Office Action Summary

10/801,634

MIZUTANI, MASASHI

DETAILED ACTION

Fig.8

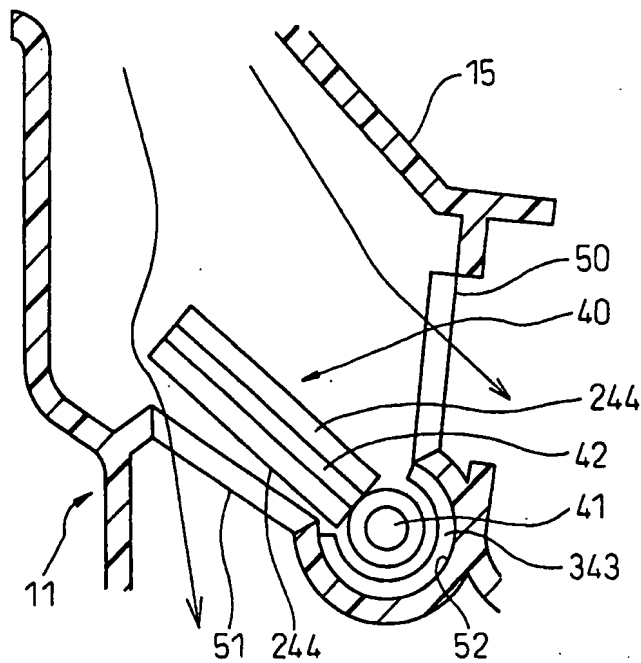
4. The replacement drawings corresponding to Figures 8 and 9 were received on April 3, 2007. These replacement drawings are hereby approved.
5. Upon reconsideration, the drawings filed on 16 March 2004 are objected to under 37 CFR 1.83(a). The drawings must show every feature of the invention specified in the claims. Therefore, the following features must be shown or the feature(s) canceled from the claim(s): a device for opening and closing a passage provided with both a small diameter shaft portion and a large diameter shaft portion with a packing member disposed between the shaft and the bearing hole of a case wherein the packing member is further ONLY attached to the small diameter portion of the shaft as recited in claim 2. No new matter should be entered.
